**Susitna-Watana Hydroelectric Project  
(FERC No. 14241)**

**Technical Memorandum:  
Characterization and Mapping of Aquatic Habitats**

June 2013

Figure 1. Locations of 20 tributaries upstream of Devils Canyon selected for habitat mapping.

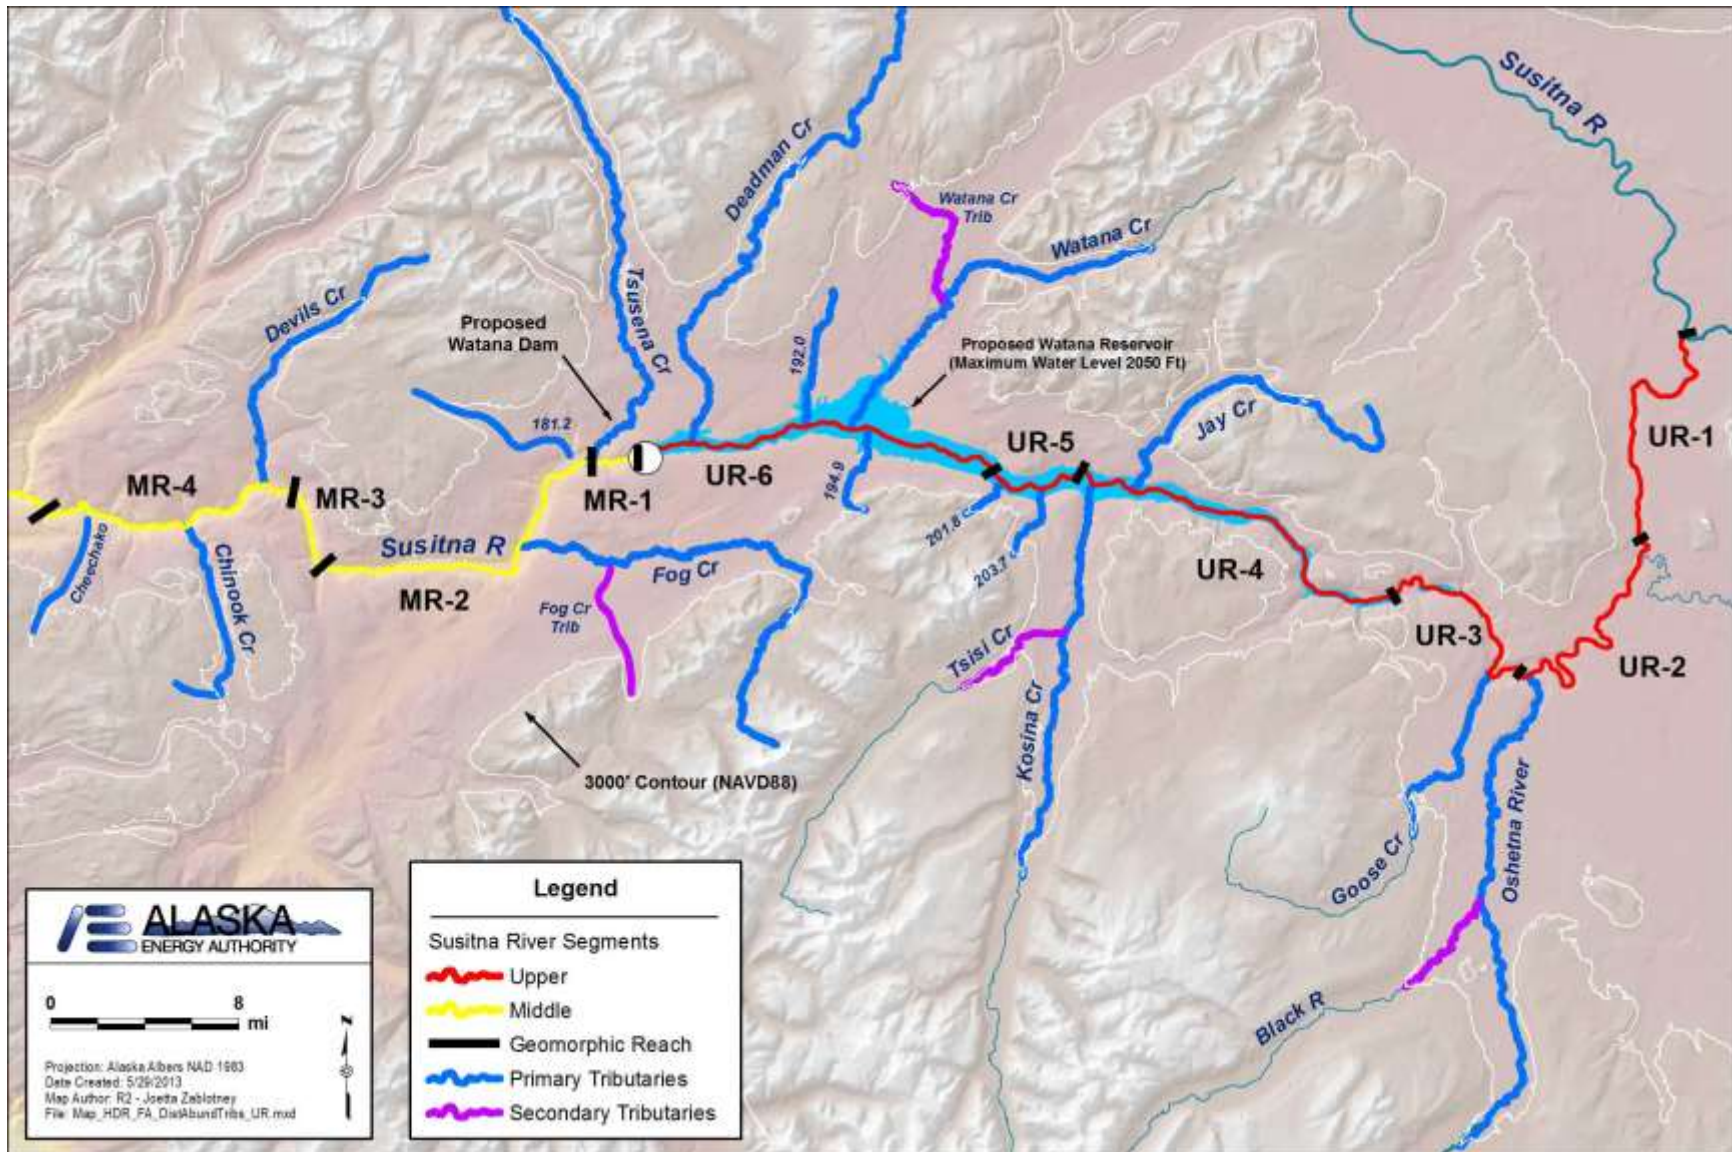
The 20 tributaries listed in Table 1 represent the set of selection priorities described above. As seen in Figure 1 below and in more detail in Appendix B, most smaller- and lower-order tributaries that have any part in the inundation zone are short, appear to be steep, and only have a small portion in the inundation zone.
